Proposal for Supplement 4 to the 03 and Supplement 1 the 04 Series of Amendments of UN Regulation No. 100 (Electric power-train vehicles)

Submitted by the experts from the International Association of the Body and Trailer Building Industry (CLCCR)

Figure 1
Generic description of test pulses

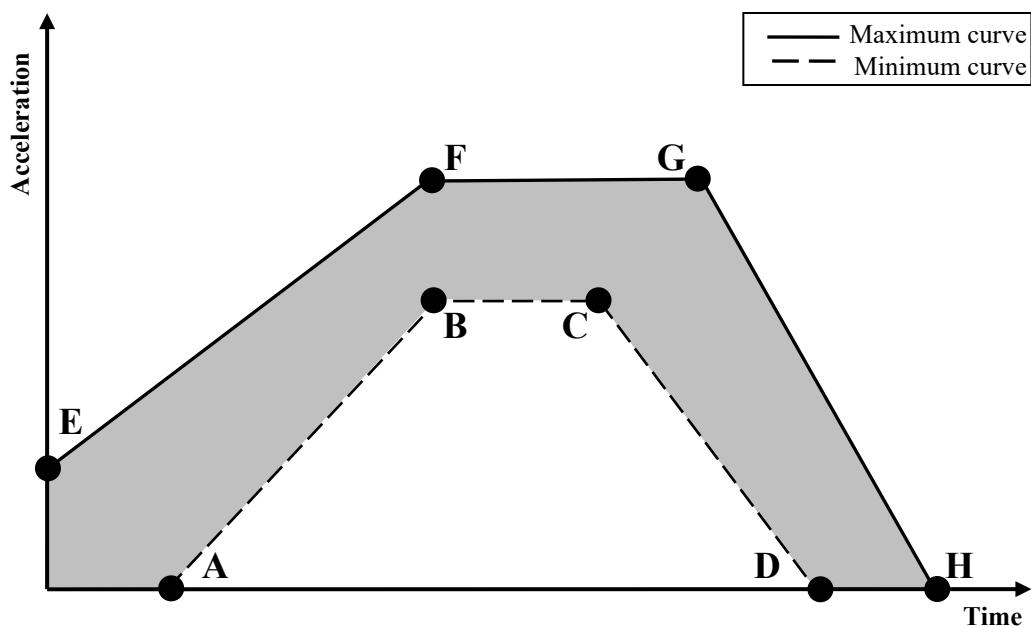
Annex 9C Mechanical shock Paragraphs 3.2. amend to read:

The Tested-Device shall be decelerated or accelerated in compliance with the acceleration corridors which are specified in Tables 1 to 3. The manufacturer shall decide whether the tests shall be conducted in either the positive or negative direction or both.

The test pulse shall be within the minimum and maximum value as specified in Tables 1 to 3. A higher shock level and /or longer duration as described in the maximum value in Tables 1 to 3 can be applied to the Tested-Device if recommended by the manufacturer.

Table 1 for M₁, and N₁, O₁ and O₂ vehicles¹:

Table 3 for M₃, and N₃, O₃, O₄ vehicles:

Add new footnote 1 in Annex 9C Mechanical shock Paragraphs 3.2. table 1:

- 1 For vehicles of category O₁ and O₂ at the request of the manufacturer the pulses defined in table 2 of Annex 9C paragraph 3.2 may be used if the maximum design speed of these vehicles of category O₁ and O₂ is limited to 100 km/h.

The resistance against mechanical shock is focusing on pulses of crash tests or similar performance tests of vehicles of category N1, N2, N3, M1, M2 and M3. Trailers are normally not in the scope of crash test regulations due to missing passengers. Therefore, it is recommended to define the performance pulses for trailers in relation to the category of the trailer and its real use-case.

REESS on O1/O2 may be tested with the pulse as defined for M1/N1 (Table 1), because they are the most common towing vehicles. Nevertheless, with few exceptions, the speed limits worldwide are lower for the combination of towing vehicle and trailer than those for the M1/N1 vehicles alone. Furthermore, the actual deceleration of a REESS into a trailer is lower than on a motorized vehicle because it is somehow mitigated, in the event of a crash, by the presence of the towing vehicle itself. Therefore, an option should be given to the manufacturers of O1/O2 to test their REESS according to the specifications provided for M2/N2 (Table 2), if their design speed is limited to 100 km/h.

REESS for O3/O4 may be tested with a pulse related to requirements for N3/M3, again because they are their most common towing vehicles.
